DOCUMENT CHANGE REQUEST

DCR number 266	Changes required for: General	Originator: Ron Fidler
Date: 2006/07/24	Date sent: 2006/07/24	Organisation: ESA/ESTEC
Status: IMPLEMENTED

Title:	Transistors Low Power RF NPN, based on type 2N3019		
Number:	5201/011	Issue:	1

ESCC Detail Specification No. 5201/011

Metal Can Package (TO-39) - 3 lead

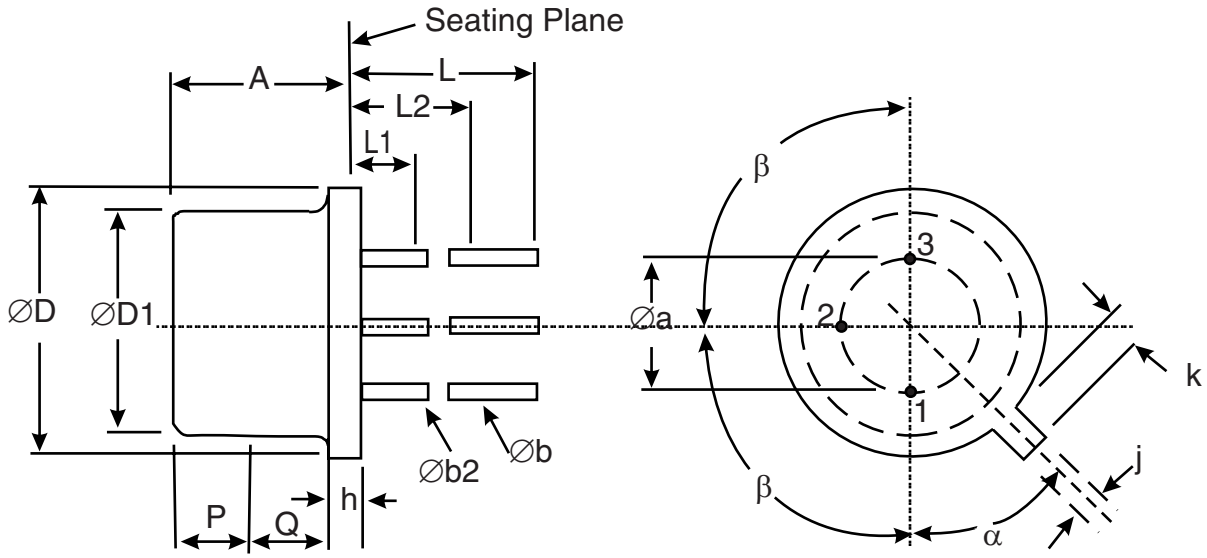
6. Figure 2 - Dimensions .a. and .b. corrected from "NOMINAL" to "BSC". The drawing harmonized with TO-39 outlines for similar STM components.

Symbols	Dimensions mm		Notes
	Min	Max	
∅a	4.83	5.35	
A	6	6.6	
∅b	0.4	0.533	2, 3
∅b2	0.4	0.483	2, 3
∅D	8.31	9.4	
∅D1	7.75	8.51	5
h	0.229	3.18	
j	0.71	0.864	
k	0.737	1.14	4
L	12.7	19	2
L1	-	1.27	2, 3
L2	6.35	-	2, 3
P	2.54	-	5
Q	-	-	6
α	45° BSC		1, 7
β	90° BSC		1

VOLTAGE WAVEFORMS

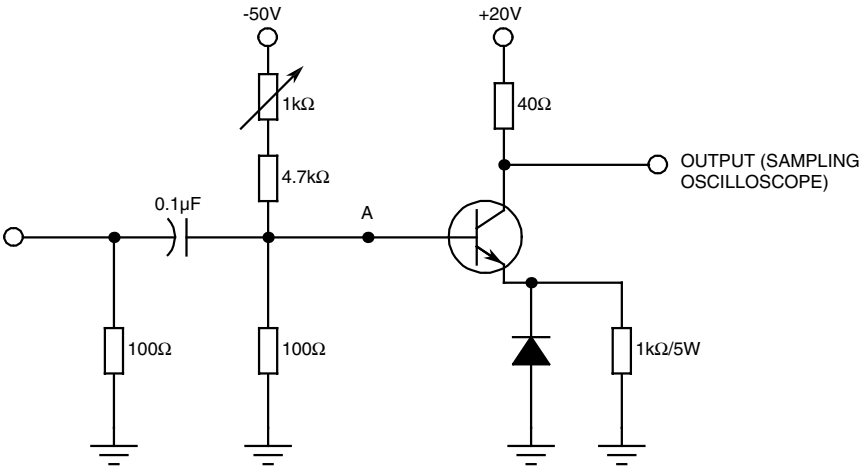
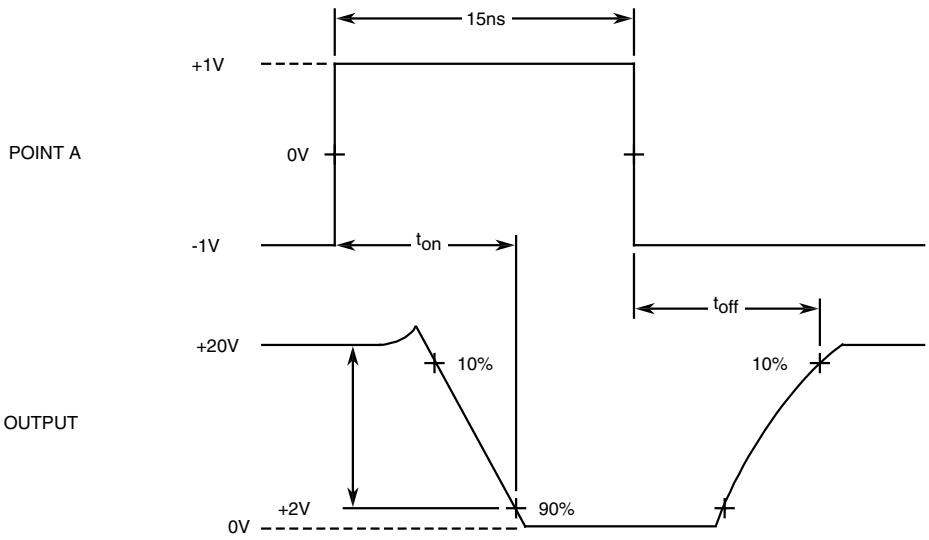
15. Table 2 and Figure 4 - For tON and tOFF tests a new Note 4 added which fully defines the tests based upon the test circuits and conditions used by STM and MIL specification, showing the test circuit and the corrected waveforms.

$Z_{IN} \geq 100k\Omega$, $C_{IN} \leq 12pF$, $t_r \leq 5ns$.

Diode is 1N3064 or equivalent.
